UNITED STATES PATENT AND TRADEMARK OFFICE

APPLICATION NO.	FILING DATE	FIRST NAMED INVENTOR	ATTORNEY DOCKET NO.	CONFIRMATION NO.
09/912,460	07/26/2001	Tatsuya Kawahara	77661/55	5110

Office Action Summary

DETAILED ACTION

FIG. 1

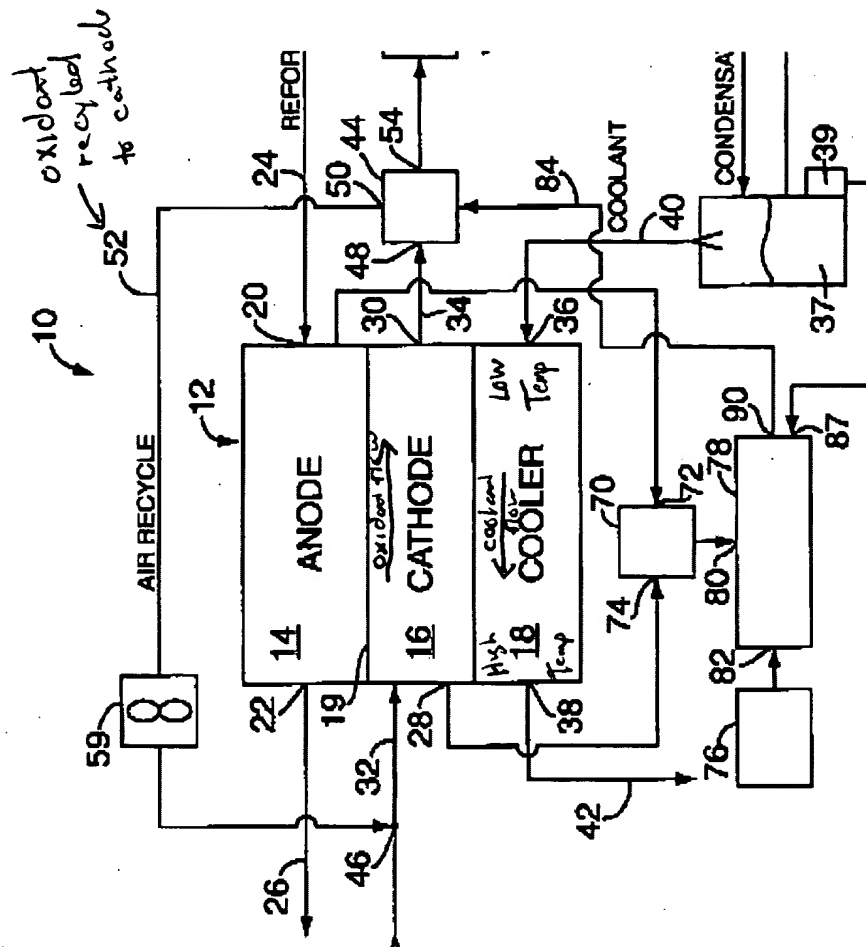
Bonville discloses a PEM fuel cell (abstract) including a high temperature portion (outlet end of coolant line across the fuel cell) and a low temperature region (inlet end of coolant line across the fuel cell) the fuel cell comprising: an oxidant passage formed in cathode 16, wherein an oxidant flow is directed from the high temperature portion to said low temperature portion of the fuel cell so that water produced during operation of the fuel cell recirculates in said oxidant passage (Fig. 1 as applied to claim 1).

The low temperature portion is located at a higher position than the high-temperature portion, relative to the coolant outlet side of the fuel cell (Fig. 1 as applied to claim 2).

The fuel gas passage formed in anode 14 includes a gas inlet and gas outlet wherein the fuel gas flow is directed from the low-temperature portion to the high-temperature portion, said fuel gas outlet is positioned lower than said fuel gas inlet relative to the fuel gas outlet side of the fuel cell (Fig. 1 as applied to claim 9).

Self-humidification of the cell is conducted due to the recirculation of the product water to the oxidant passage (as applied to claim 10).
